**Special Standard
 PUD Zoning District**

**CCES
 Responses**

Project Name: Villages at Sterling Ranch

PCD File No.: PUDSP-226

PRIVATE ROAD (30' WIDE TRACT)

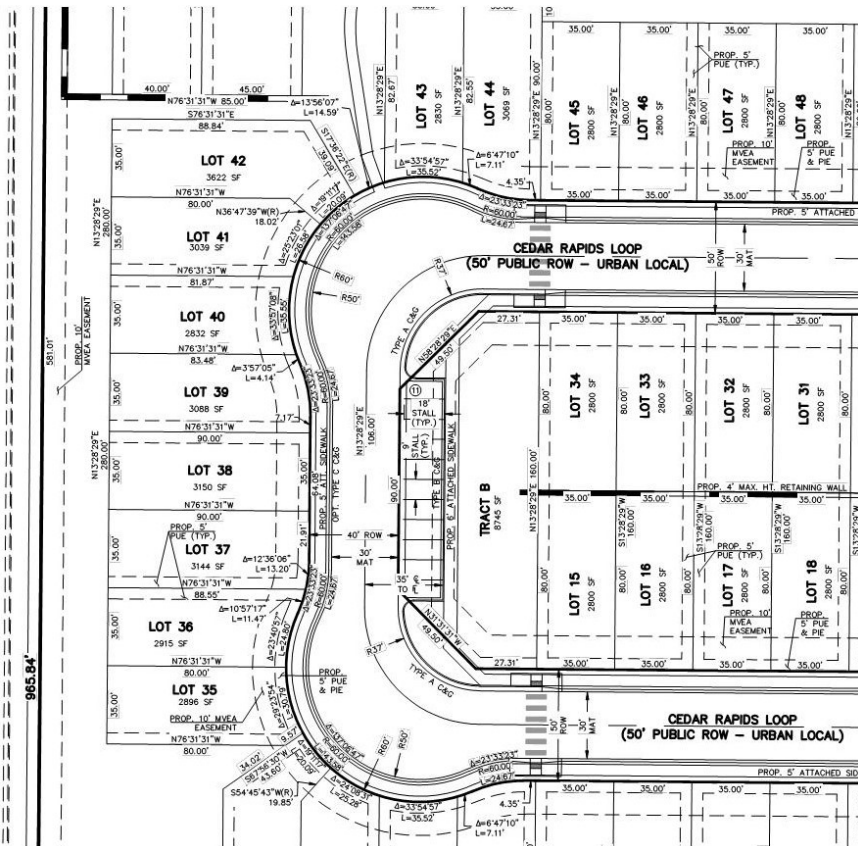
- LDC 8.4.4 (C)**
Special Standards: **Public roads required – division of land, lots and tracts shall be served by public roads**
Some lots within this development will be directly accessed from private roads within a 30' wide tract. These specific lots will directly abut the private road tract that will be owned and maintained by the Sterling Ranch Metropolitan District. These private roads then connect directly with Public Right-of-Way.
- LDC 8.4.4 (E)(3)**
Special Standards: **Private roads to meet County standards**
Private roads functioning as an alley cannot meet all County public road standards, thus, the following represent the private road standards:

- 30' wide Private Road Tract owned and maintained by Metro. District
 - Pavement mat = 22.0'
 - Optional Type C C&G each side
 - Curb Return radius = 15'
 - Pavement design per County stds.
 - Design/Posted Speed = 20 mph

- No sidewalks or parking (Sidewalks provided to front of unit facing open space tract / Off-street parking stalls provided throughout site)
- Reference City of Colorado Springs Residential Alley Standard for similar criteria (Fig. 20, City of C.S. Traffic Criteria Manual)

3. LDC 6.2.5.C.3(g) Special Standards:

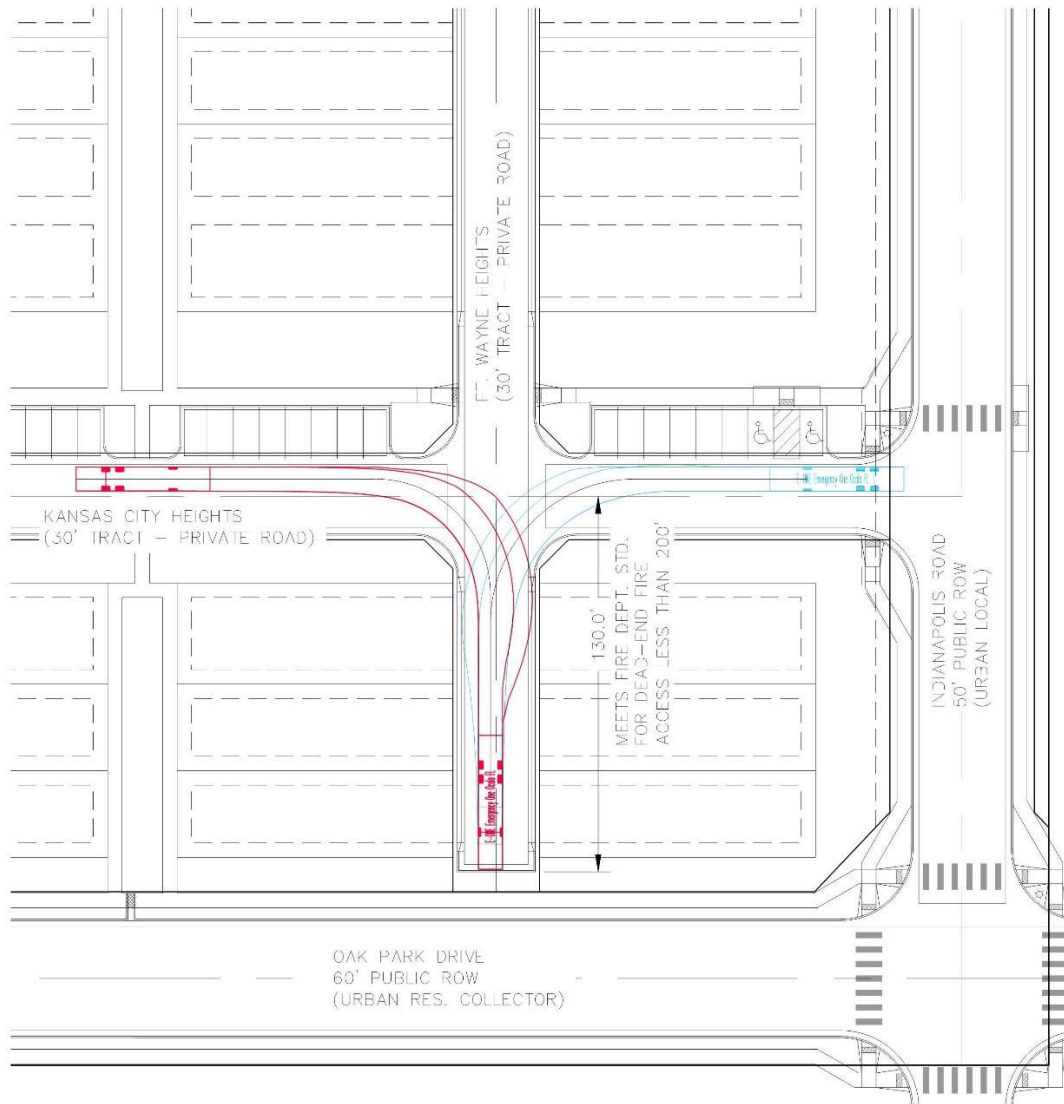
Now included in item 1

Revise this one to be a deviation to standard road section, ROW width. (Just change section and title, I think the actual justification & exhibit are fine)

- 40' ROW adjacent to parking stalls
- 30' pavement mat remains consistent
- 20' parking depth provided to allow parking outside of public ROW
- Parking stalls within adjacent tract owned and maintained by Metro. District.
